# Village of Shorewood Hills PUD Rezoning Request

Re: Rezoning from C-3 to Planned Unit Development  
General Development Plan  
2801-2725 Marshall Court

Re: Review of the proposed rezoning of 2725-2801 Marshall Court: “Arbor Crossing II”  
From: Medical Office-Commercial (C-3)  
To: Planned Unit Development (PUD) / General Development Plan (GDP)

**To:** Shorewood Hills Plan Commission Members  
**CC:** Karl Franz, Village Administrator  
Mike Slavney, Vandewalle & Associates  
**From:** Scott Harrington, AICP  
**Date:** February 29, 2016  
**Re:** Arbor Crossing II Height Exception Analysis

**C-1.0**

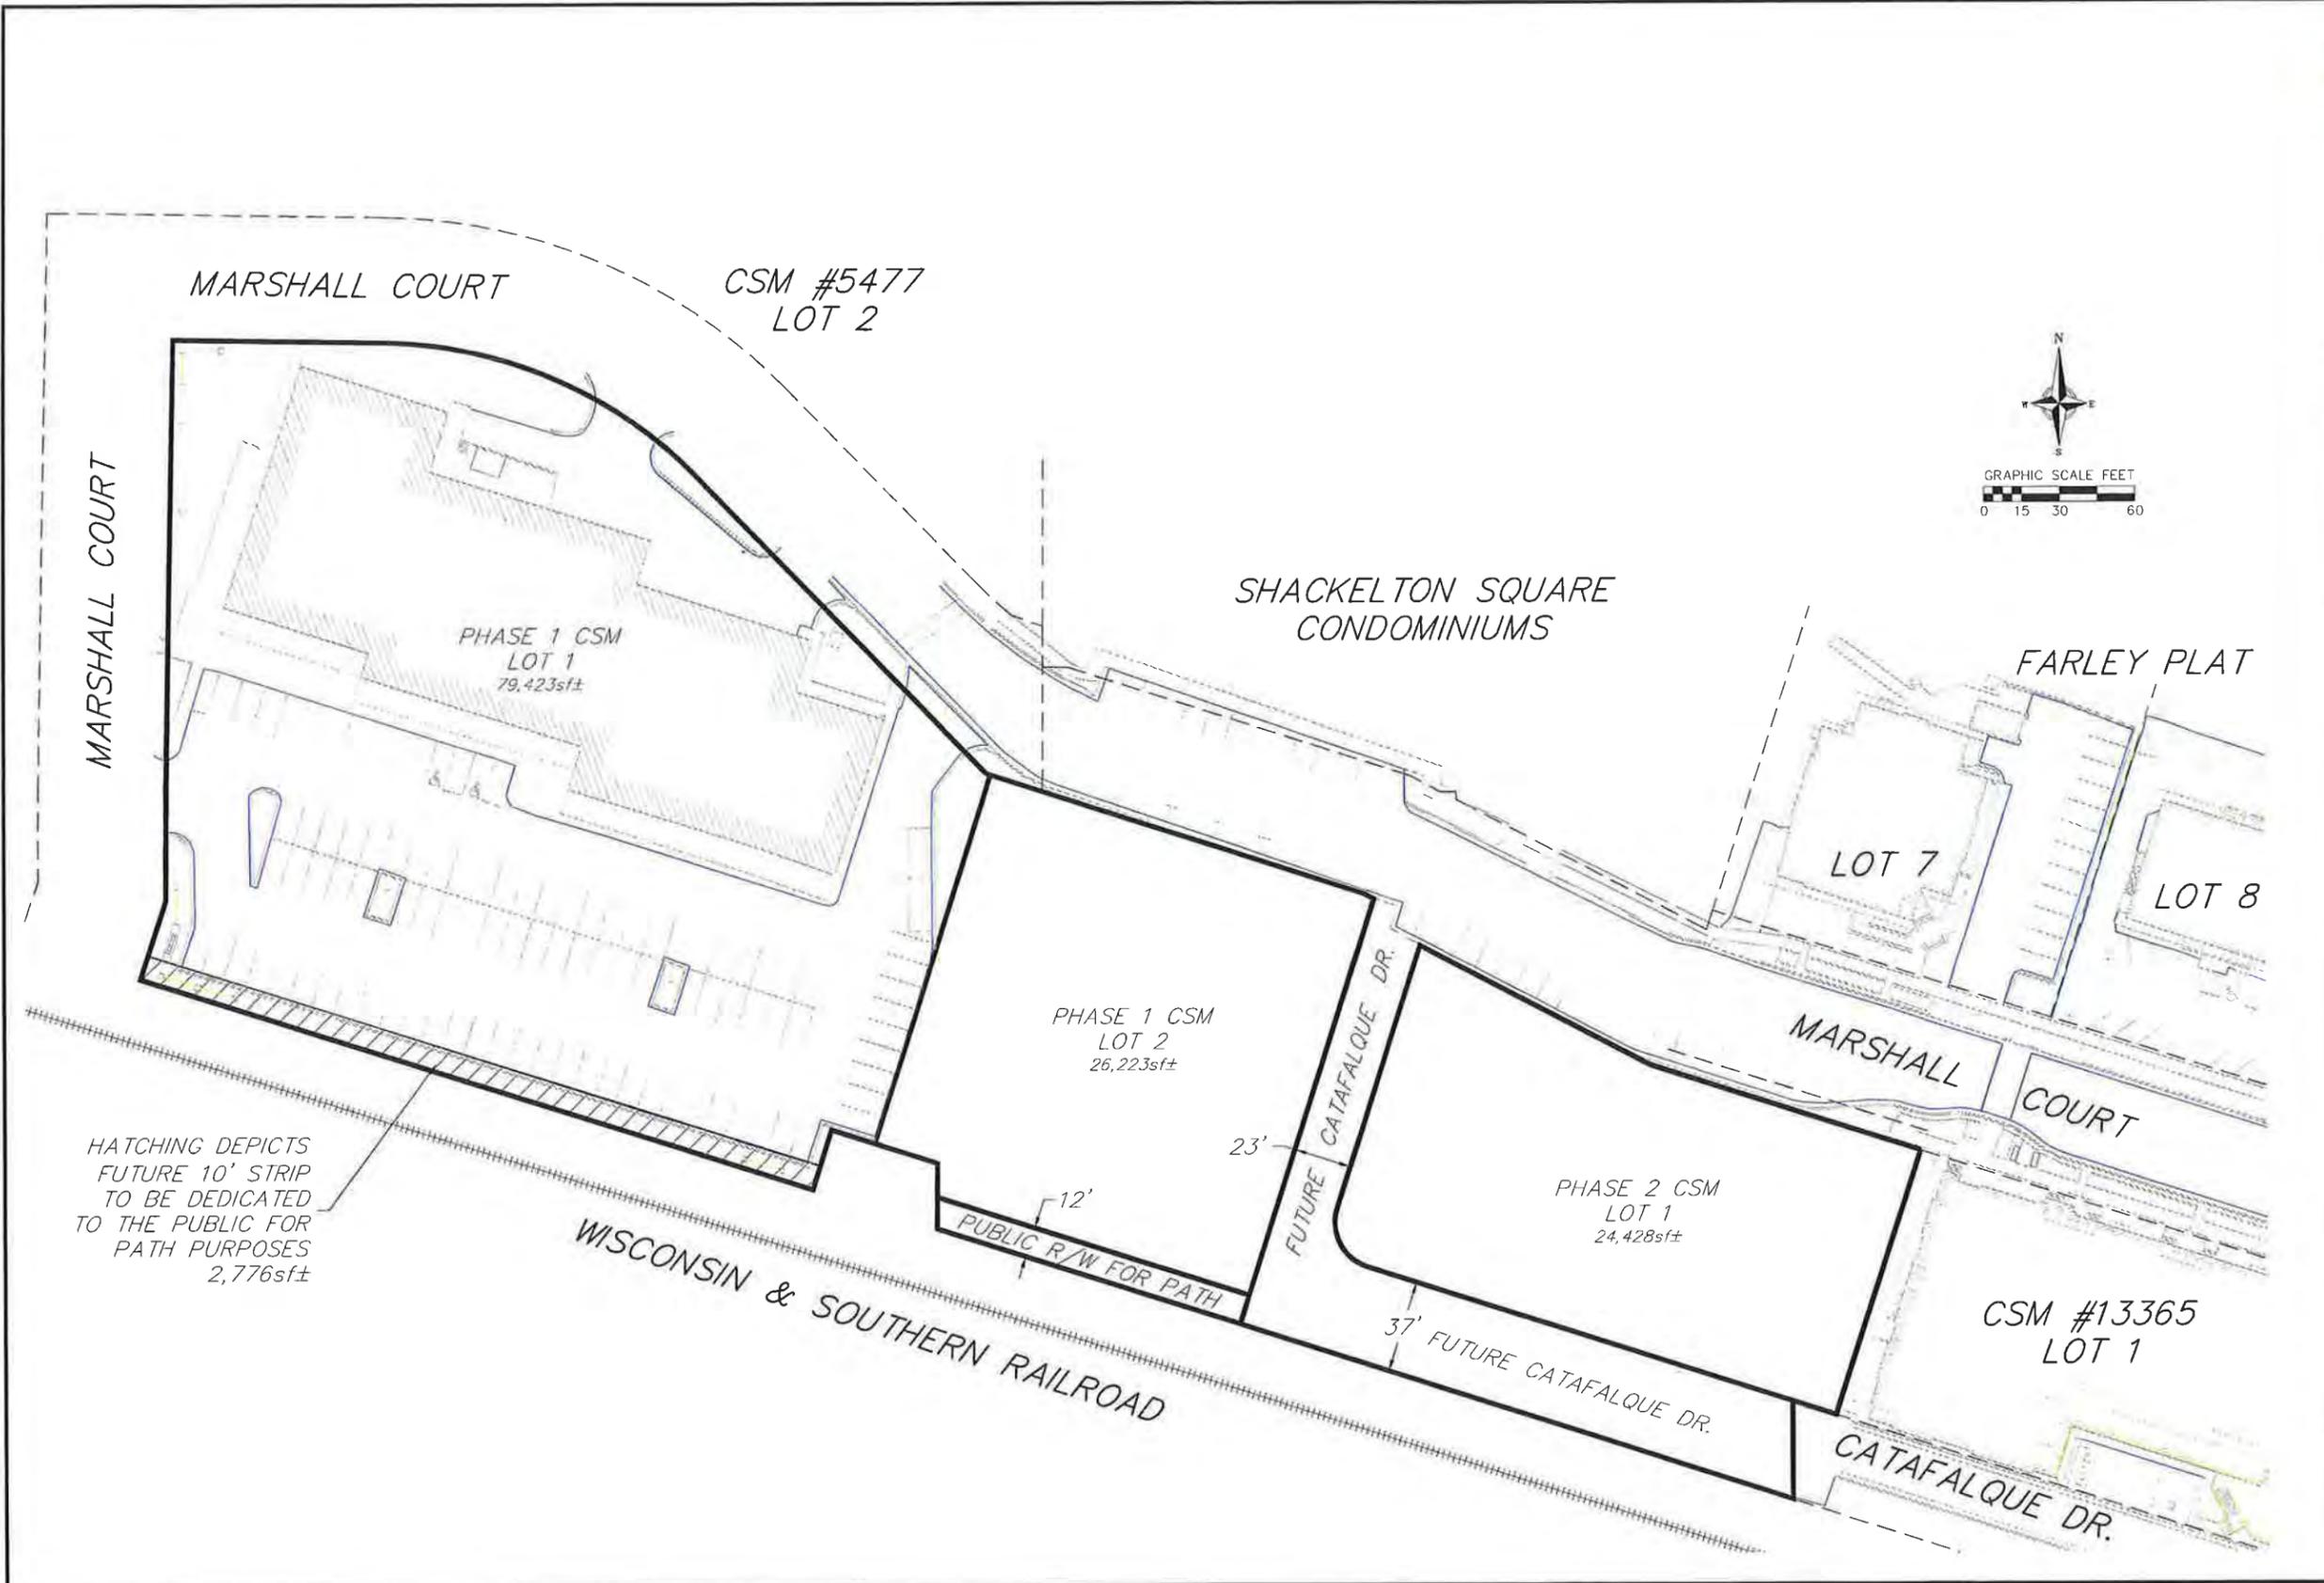
- Sheet C-1.0: Site Plan depicting the proposed development in plan view.
- Sheet C-1.0A: GDP Limits Exhibit Map depicting the boundaries of the GDP.
- Sheet C-1.0B: GDP CSM Phasing & Right-of-Way Configuration Map showing the boundaries of Phase 1 and Phase 2, and the areas proposed for street and bike path dedication.

**Figure 1 Marshall Court 2016 Traffic Review Study Area**

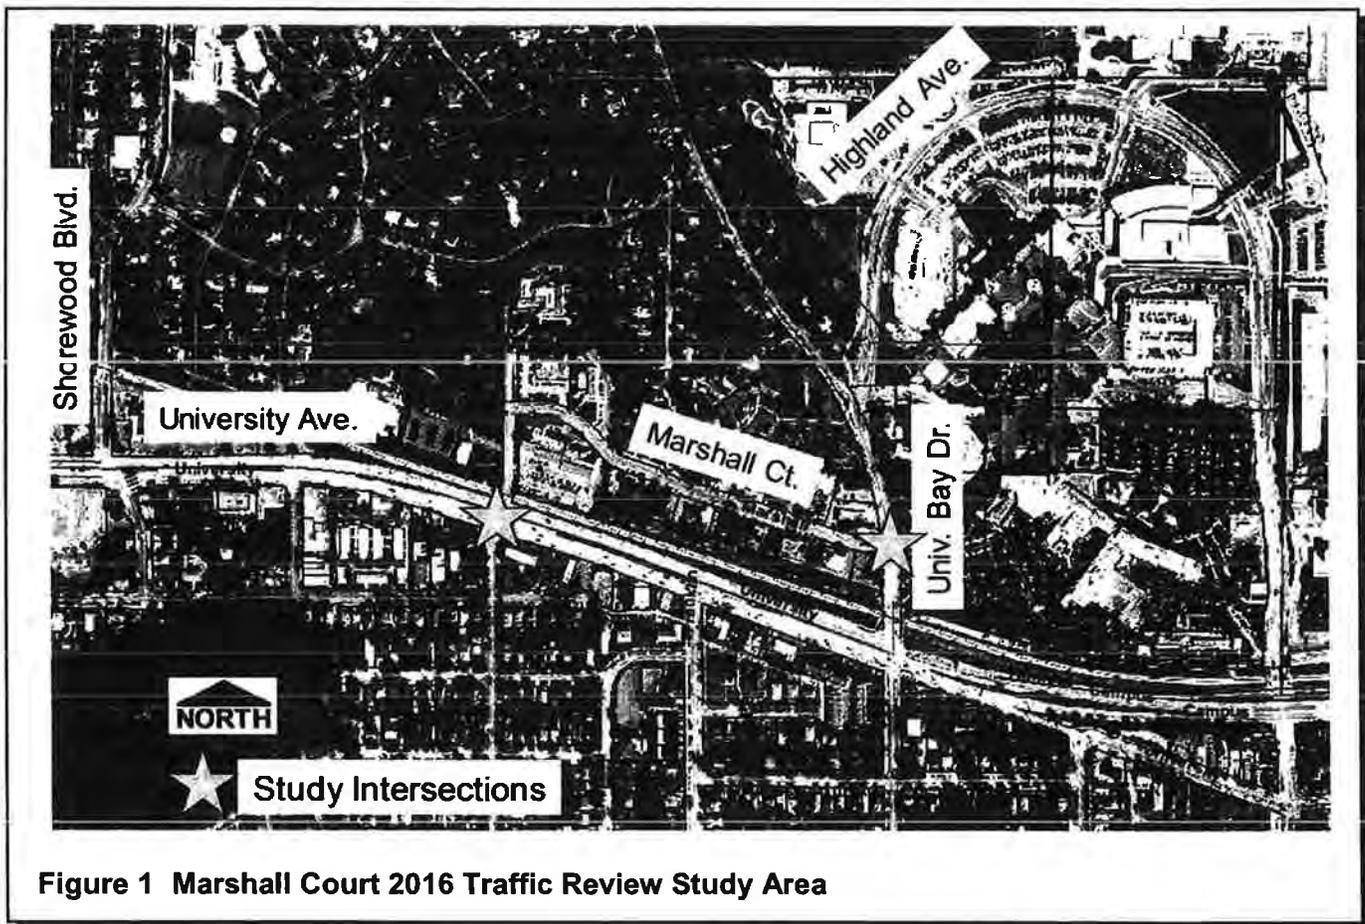
At the request of Village staff, Strand Associates, Inc.<sup>®</sup> (Strand) completed a review of traffic conditions on Marshall Court from University Avenue to University Bay Drive. This report includes a summary of previous studies and plans for the area and discusses data related to traffic volumes, parking occupancy, crashes, and speeds on Marshall Court.
